Generic Environmental Impact Statement for License Renewal of Nuclear Plants

Supplement 38

Regarding Indian Point Nuclear Generating Unit Nos. 2 and 3

Draft Report for Comment

3 **Figure 4-3. Percentage of entrainment composed of RIS fish and total identified fish**
4 **relative to the estimated total entrainment at IP2 and IP3 combined**
5 **(data from Entergy 2007b)**

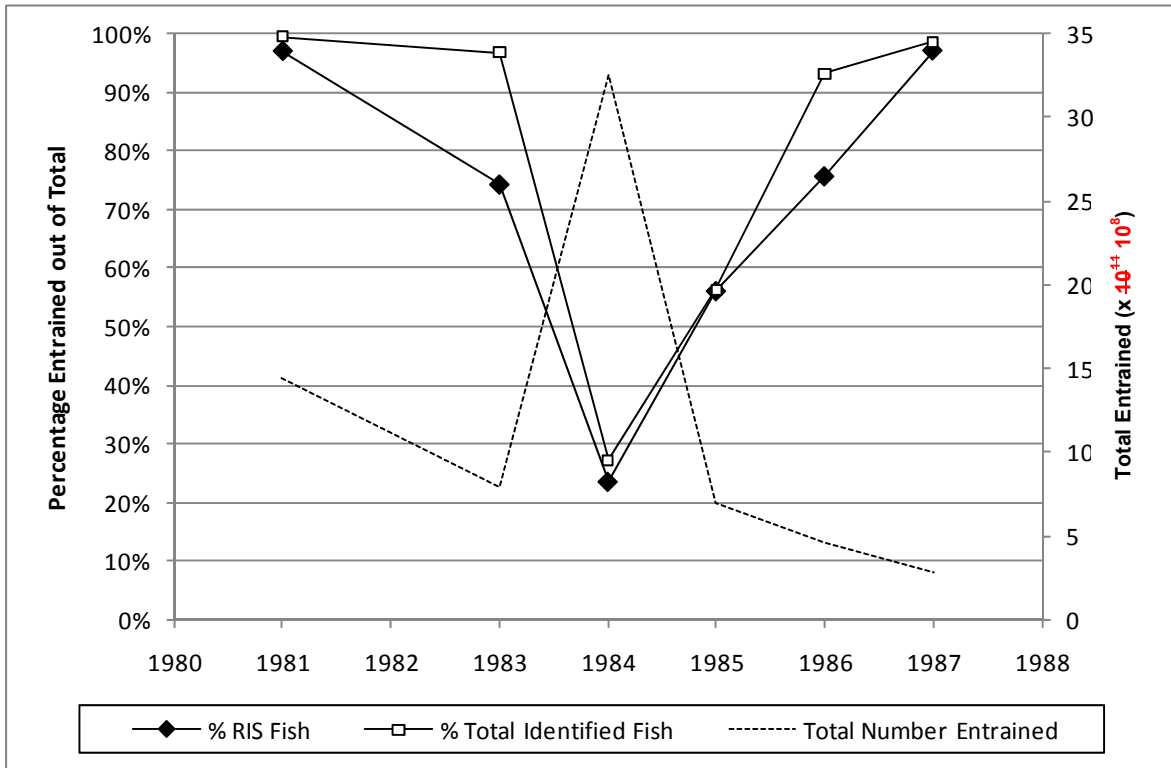
In the FSEIS, the NRC staff estimated the number entrained for a given week as the product of the mean density entrained and the combined weekly flow for IP2 and IP3. The error in the entrainment catch density directly affects Figure 4-3 in Section 4.1.2, and the error is repeated in Figure H-5 in Appendix H. In these figures, the total number entrained on the right axis should be in units of numbers $\times 10^8$ instead of numbers $\times 10^{11}$. The corrected Figures 4-3 and H-5 appear below. In addition, these changes affect two portions of text in the FSEIS.

1 **Figure 4-3 on page 4-15 in the FSEIS is corrected as follows:**

Figure H-5. Percentage of entrainment composed of RIS fish and total identified fish relative to the estimated total entrainment at IP2 and IP3 combined (data from Entergy 2007b)

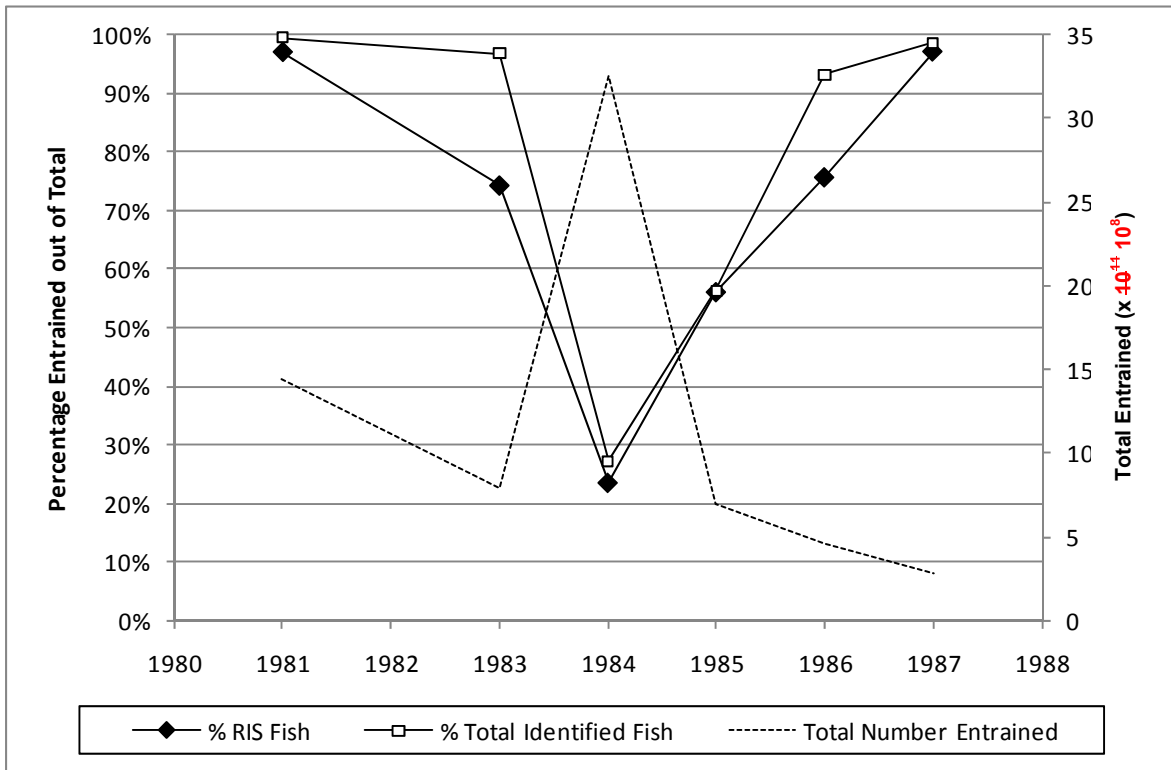
1 **Figure H-5 on page H-23** in the FSEIS is identical to Figure 4-3 in the FSEIS and is corrected
 2 as follows:
